Product Change Notice (PCN)

PCN Number: PCN-0451198R-01

Product(s) Affected: PJ-054

PREVIOUS CUI DEVICES DETAIL / IMAGE	NEW CUI DEVICES DETAIL / IMAGE

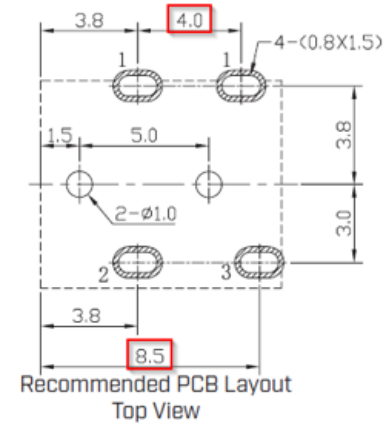
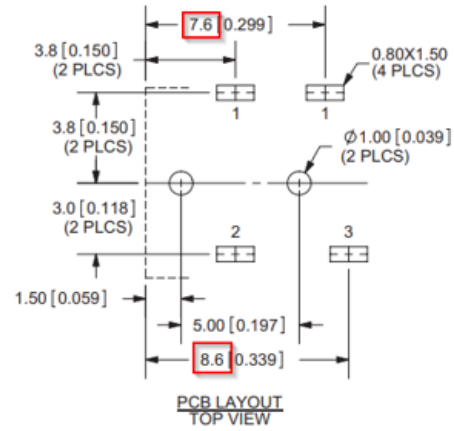
Description of Change: Mechanical, material, and PCB layout changes as noted below.

MATERIAL	PLATING
center pin	brass	nickel
terminal 1	brass	tin
terminal 2	copper alloy	tin
terminal 3	brass	tin
plastic	PA66

DESCRIPTION	MATERIAL	PLATING/COLOR
center pin	H65 brass	nickel
terminal 1	brass	silver
terminal 2	bronze	silver
terminal 3	brass	silver
housing	PA9T (UL94V-0)	black

MATING PLUG
Jack Insertion Depth: **6.2 mm**

MATING PLUG
Jack Insertion Depth: **6.1 mm**
